Office Action Summary	Application No. 10/519,743	Applicant(s) DEBERNARDI, SERGIO	
	Examiner IVES WU	Art Unit 1797

DETAILED ACTION

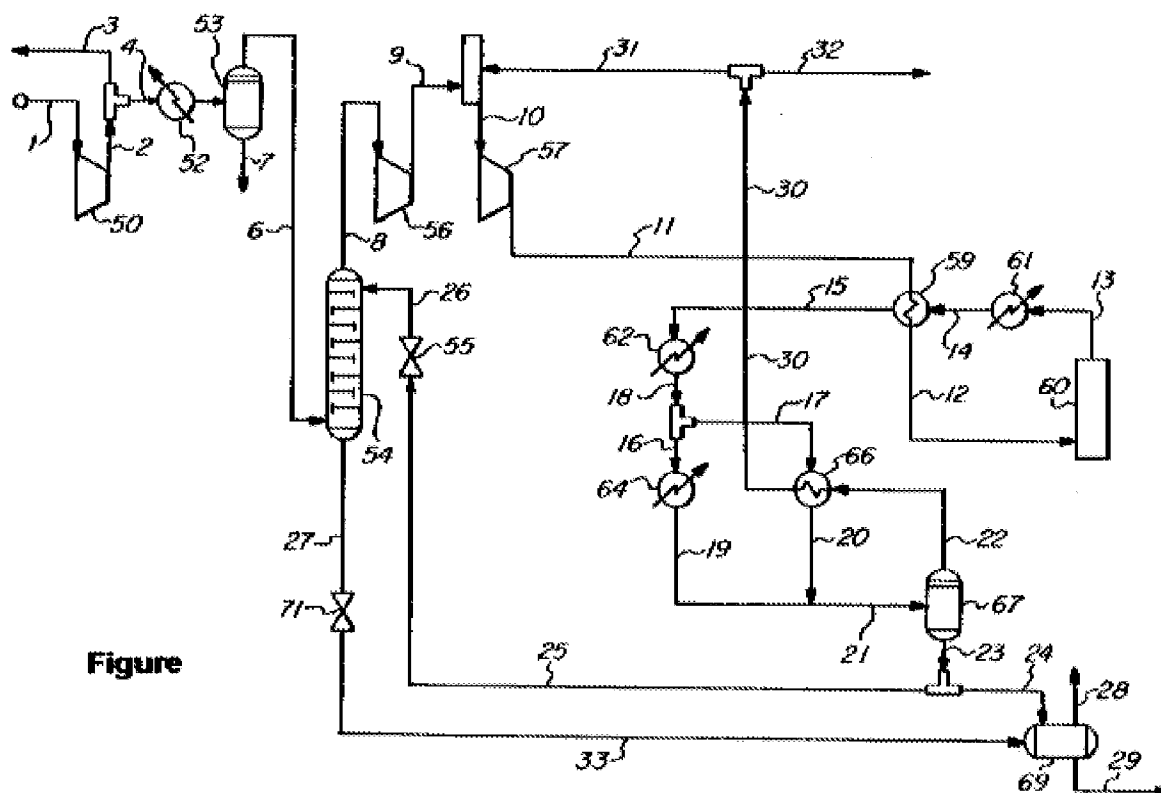
As to Method for ammonia production through a catalytic reaction of pressurized synthesis gas in an appropriate compressor with many stages, each of which is equipped with an inlet and outlet for synthesis gas, which method includes a purification step through liquid ammonia of synthesis gas from water and carbon dioxide contained in it in **independent claim 1**, Moore (WO 01/66465A1) discloses ammonia synthesis process and apparatus for use therein (Title). As illustrated in the following diagram, which include several stages of compression and inlet, outlet for each compressor, a dehydrator 54 with liquid ammonia from line 25 to contact synthesis gas from line 6 for purification.

As to cooling to be carried out upstream of the inlet of coaxial flows of synthesis gas and of liquid ammonia in mixer in **claim 4**, as shown in the Figure of Moore, the cooling is upstream of the inlet to the dehydrator.

As to at least one cooling group being placed between mixer and 1st stage of compressor in **claim 9**, the Figure of Moore shows the cooling group 52 between mixer and 1st stage compressor.

Figure

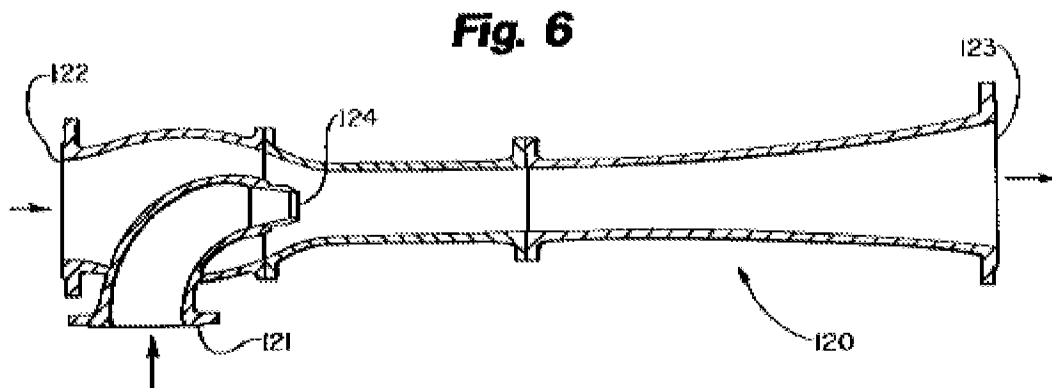
As to step of axially feeding into mixer a flow of synthesis gas outbound from 1st stage or from intermediate stage at the same time as a flow of liquid ammonia flows being coaxial and in co-current in method in **independent claim 1**, as illustrated in Figure 6 of Torkildsen et al (WO 99/13963), which reads on this limitation of instant claim.

As to flow of liquid ammonia being fed into mixer in the form of a plurality of high speed jets in **claim 5**, Torkildsen et al (WO 99/13963) disclose the jet pump 120 in Figure above, which would generate jet of liquid droplets (page 2, line 13-14, page 10, line 6-15). It would be obvious to have plurality of high speed jets arranged because duplication of parts is obvious. *In re Harza*, 274 F.2d 669, 124 USPQ378 (CCPA 1960).

As to flow of liquid ammonia being fed into mixer making it pass through a nozzle equipped with appropriate suitably sized openings or slits in **claim 6**, the Figure 6 above of Torkildsen et al would read on the instant claim - nozzle.

As to nozzle equipped with appropriate suitably sized openings or slits in fluid communication on one side with portion of reduced cross-section of mixer and on the opposite side with a line for feeding a flow of liquid ammonia into mixer in **claim 10**, Torkildsen et al (WO 99/13963) disclose the jet pump to generate the liquid droplets page 2, line13-14) together with the Figure 6, which reads on the instant claim.
